FED. ROAD DIST. NO.	STATE	FED. AID PROJ. NO.	FISCAL YEAR	SHEET NO.	TOTAL SHEETS
HAWAII	HAW.	5-0470(1) 5-0470(2)	1970	42	80

SUPPLEMENT SHEET
ADDENDUM NO. 1
October 12, 1970

ADDENDUM NO. 1
October 12, 1970

STATE OF HAWAII DEPARTMENT OF TRANSPORTATION HIGHWAYS DIVISION
TYPICAL DETAILS CONSTRUCTION IDENTIFICATION SIGN AND WOOD BARRICADES
Scale: As Shown Date:

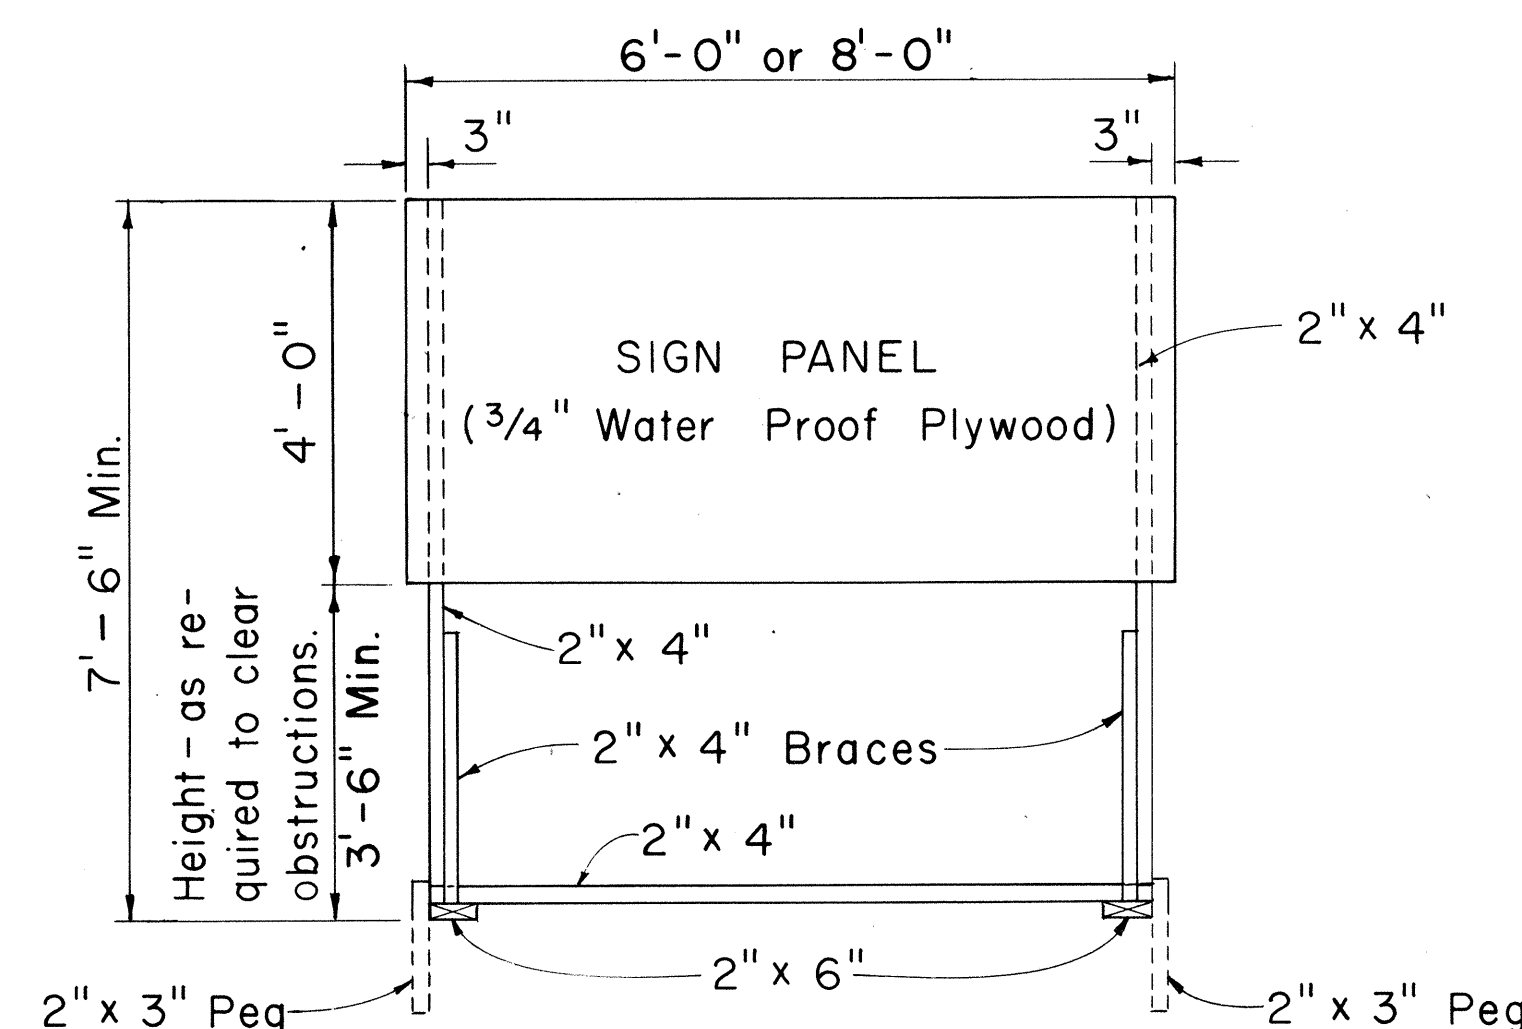
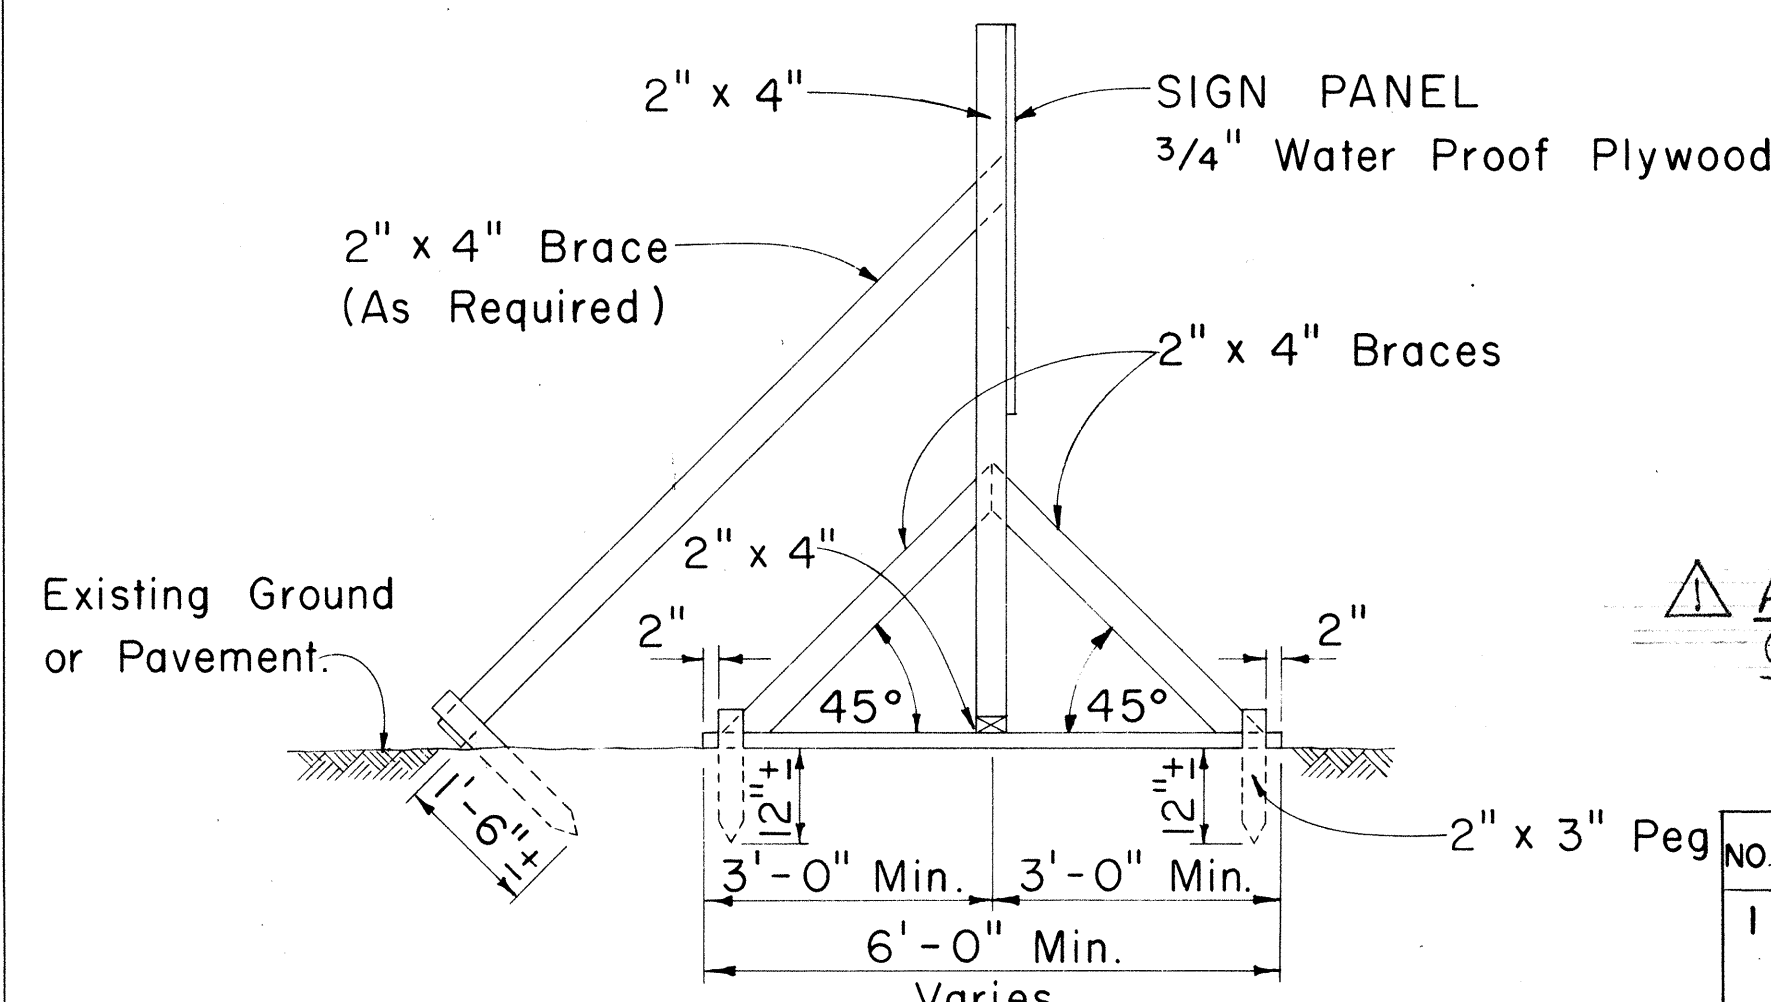
NO.	REVISION	APPROVED BY	DATE
1	Delete "Bureau of Public Roads"	ft.	9-29-70
